## ***Interactive comment on “Simulation of rock salt dissolution and its impact on land subsidence” by A. Zidane et al.***

**A. Zidane et al.**

Authors comments to referee #1

Fig. 1.

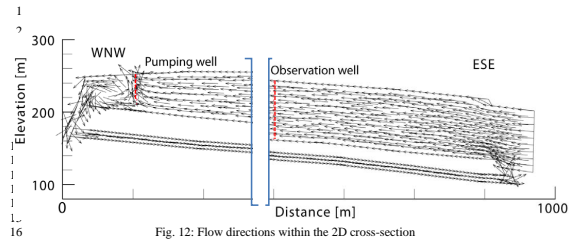
However, looking at the domain definition (Fig. 1) and on results (e.g. Fig. 5) suggests that you are simulating processes in the Upper Aquifer as well. Is that so? This is very confusing to me because you are showing boundary conditions and fault zones that reach into the Upper Aquifer in Fig. 1, and you are presenting salt distribution in the Upper Aquifer in Fig. 5. The question therefore is, what exactly is your simulation domain, and does it include the Upper Aquifer (as Figs. 1 and 5 suggest) or are you only concentrating on the fracture in the Lower Aquifer (as you appear to state on P58L25 and P66L3f)? These questions also lead to the question of the transport boundary conditions in your model domain, which are never explained. “CH” in Fig. 1 should be replaced by “constant head”.

Section 3. Definition of the conceptual model should be improved (as said above), and the same is true for the presentation of results. Why do you need a pumping well at the WNW side? Are you actually pumping? If yes, this is not possible because your model is 2D. If no, why the pump? You can simply assume constant head, without mentioning the pump. Also, what is the physical justification for your choice of flow and transport BCs (the latter are not defined)? The flow BCs suggest flow from ESE to WNW, is that so? The flow physics of all 3 test cases must be explained much more clearly. It looks as though much detail is spent on the numerical explanations, and that the physics of the test cases is not explained as clearly. This must be improved so that the reader understand what is happening physically in the 3 test cases. The same is true for the presented salt profiles. An interpretation of presented salt profiles is mostly missing. There is much more science in your results, which should be developed more fully

The simulation is applied on the entire domain as shown in Fig. 1. The domain is considered as a porous media that has the characteristics as shown in Table 1. Darcy’s equation is used to approximate the flow in the Upper Aquifer, in the fault zones and

in the Lower Aquifer, except in the void below the Lower Aquifer and on top of the salt formation, where the Stokes equation is applied. A constant concentration is imposed at the top of the salt layer. This discussion will be added to the revised manuscript and a new table will be added. CH will be replaced with constant head.

the finite elements that intersect with the well within the Upper Aquifer. The individual pumping rate of each finite element is then assigned to the sink/source term ( $Q_s$ ) in the transport equation. The flow and transport boundary conditions are added to Fig. 1. For the transport boundary conditions a zero constant concentration (relative concentration) is imposed at the inlet ESE boundary and is set to one in the lowest layer of the lower aquifer (Fig. 1a). A new figure (attached) will be added to show the flow directions in detail. In all the simulated test cases the flow directions show a similar pattern, with a general flow direction in the Upper Aquifer going from the ESE boundary towards the pumping well at the WNW boundary. The detailed figure further shows that some vectors are indicating flow underneath the well on the bottom of the aquifer, which then rises upwards parallel to the well, flows towards the WNW fault zone along the top of the Upper Aquifer, before it drops into the Lower Aquifer along the WNW side of the fault zone. This discussion, and also a more detailed description of the simulated concentration distribution in the 2D section will be added to the revised manuscript.
